ITB #2022-005 PINETREE WAY/ MEMORIAL DRIVE ROAD IMPROVEMENTS

ADDENDUM 1

CONSTRUCTION STAKING PLAN

DATE: AUG. 15 2022
 DRAWN BY: LR
 FILE NAME:
 STAKING PLAN
 SCALE: 1"=20'
 SHEET: ST-001

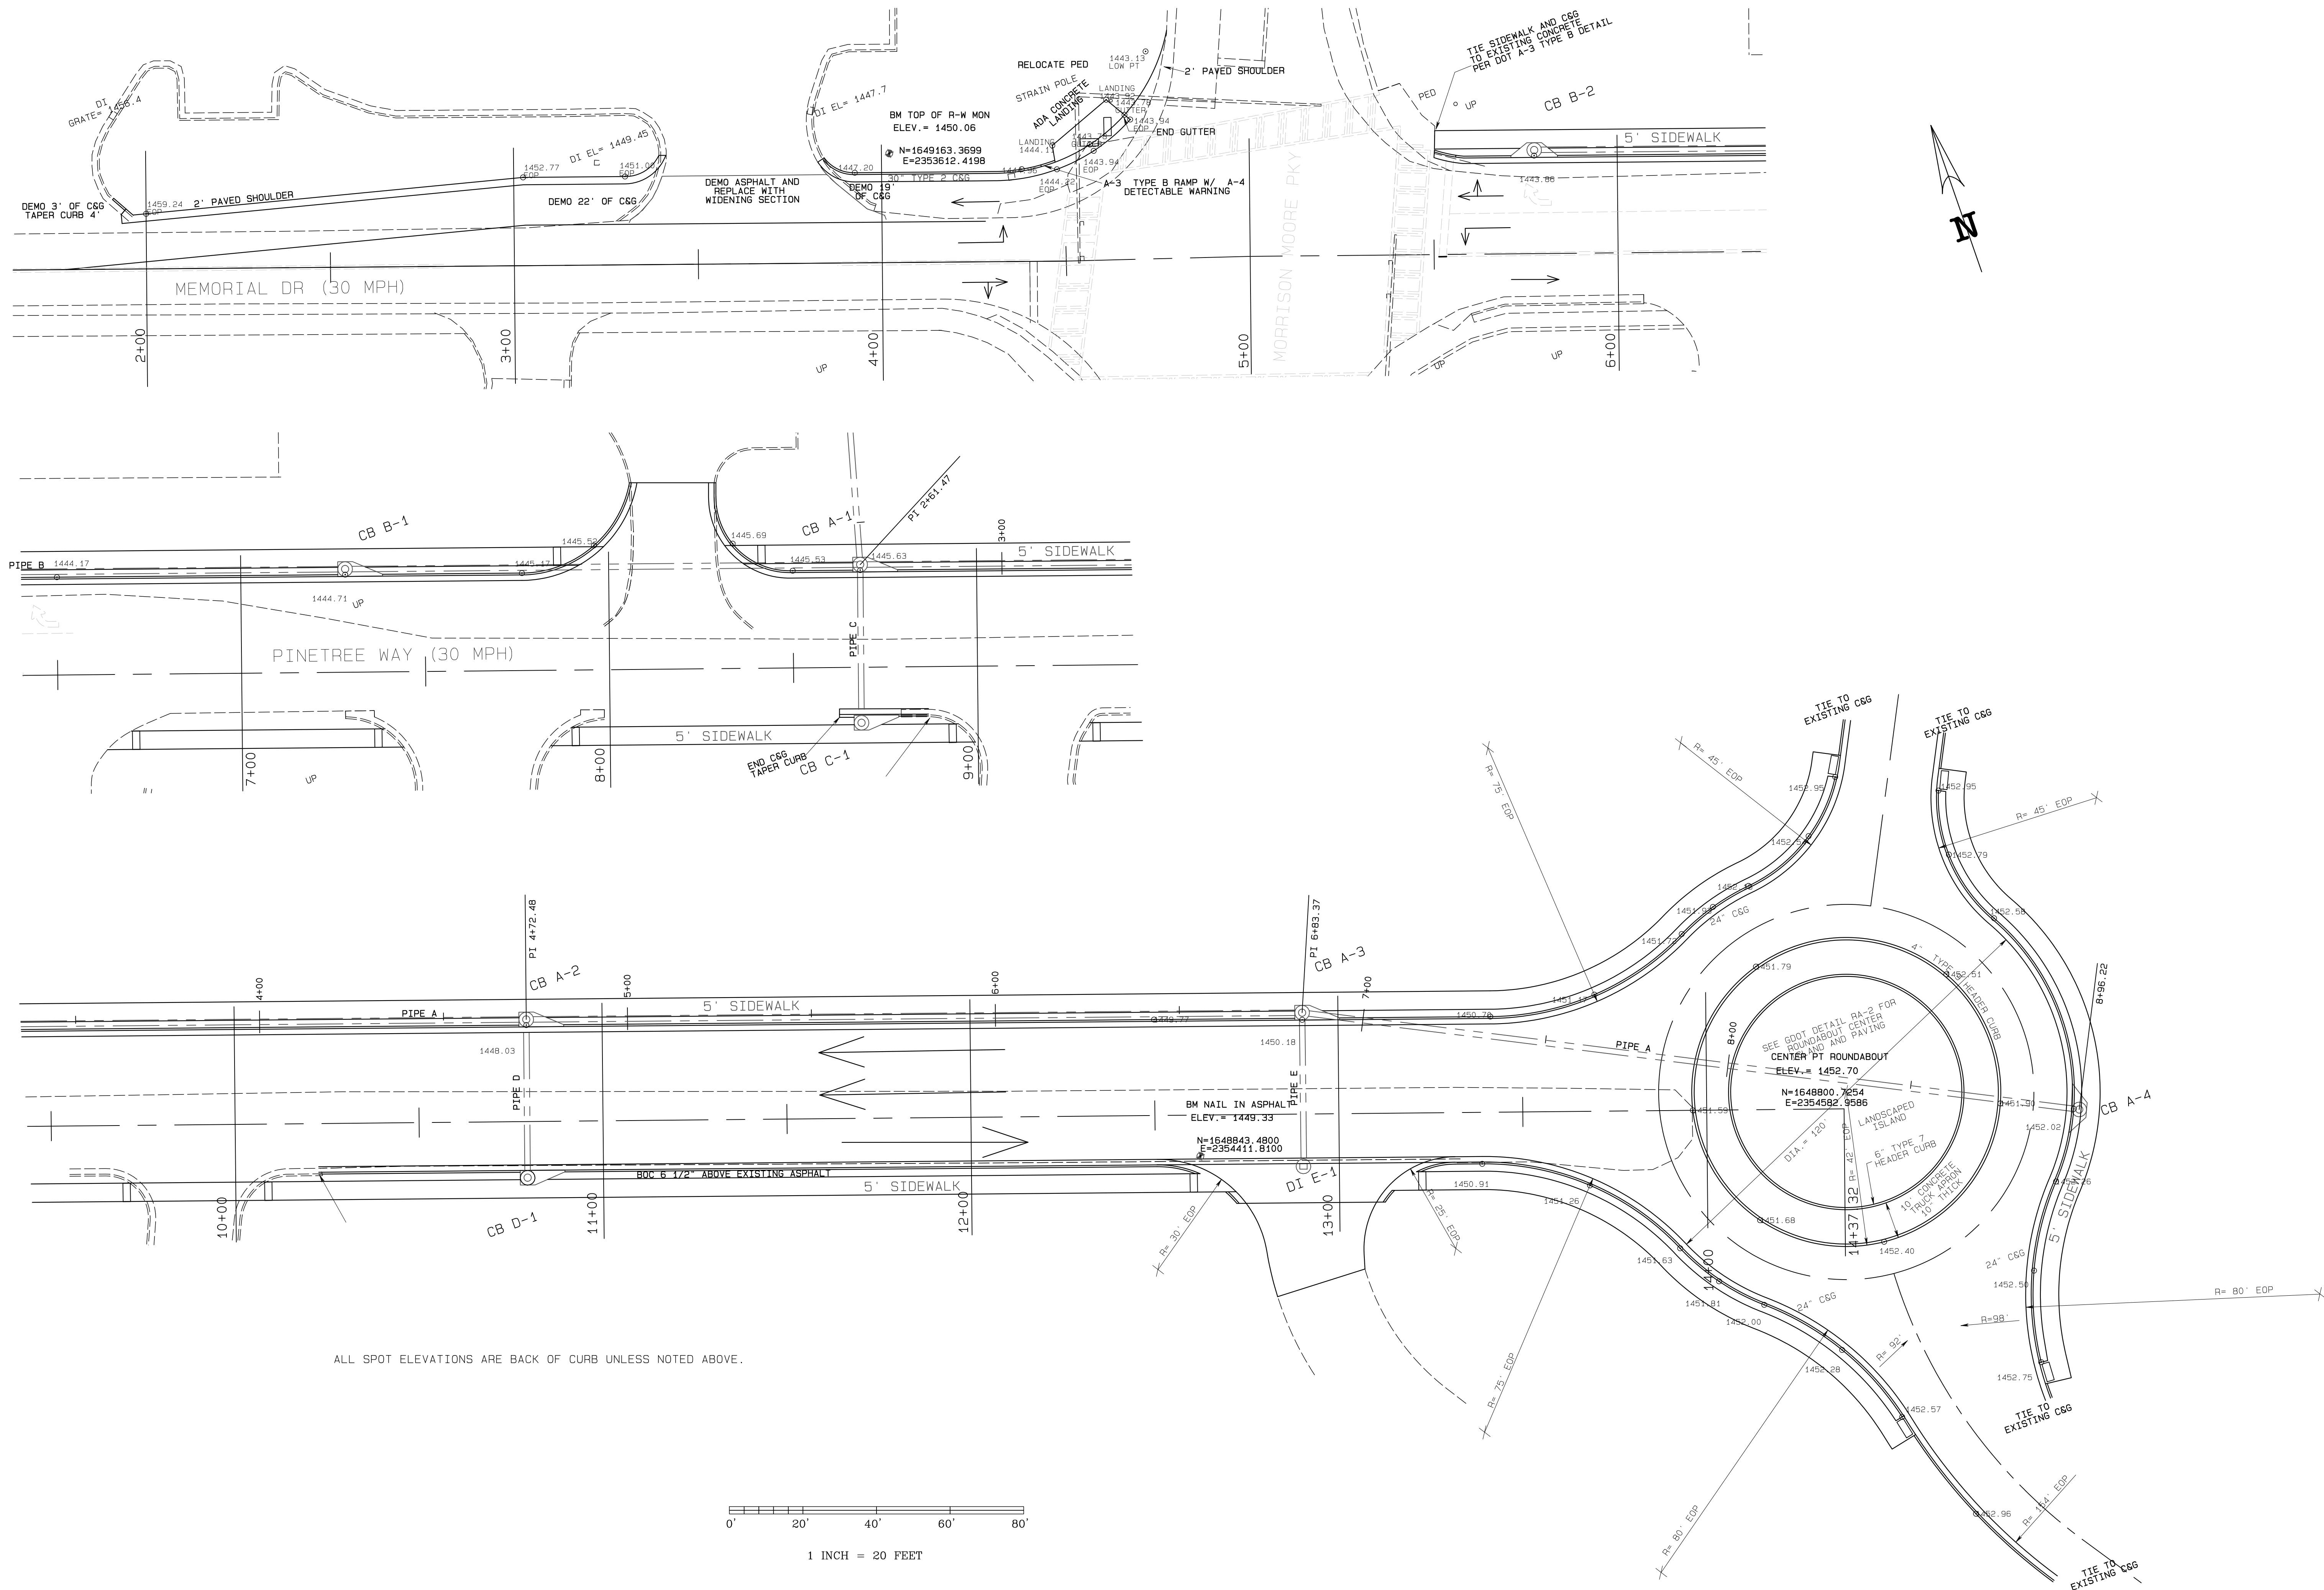
9. Is there a cost estimate to move the power pole belonging to Georgia Power that is behind the fire department?
 - a. One has not been provided at this time.
10. Verify process for abandoning the existing water line?
 - a. Water line may be capped and left in place.
11. Provide benchmark elevation.
 - a. See attached.
12. Will vendor need to phase traffic for construction to continue on the school construction project?
 - a. No. A construction entrance will be created for them to use.
13. Is there any lighting in the project?
 - a. No lighting.
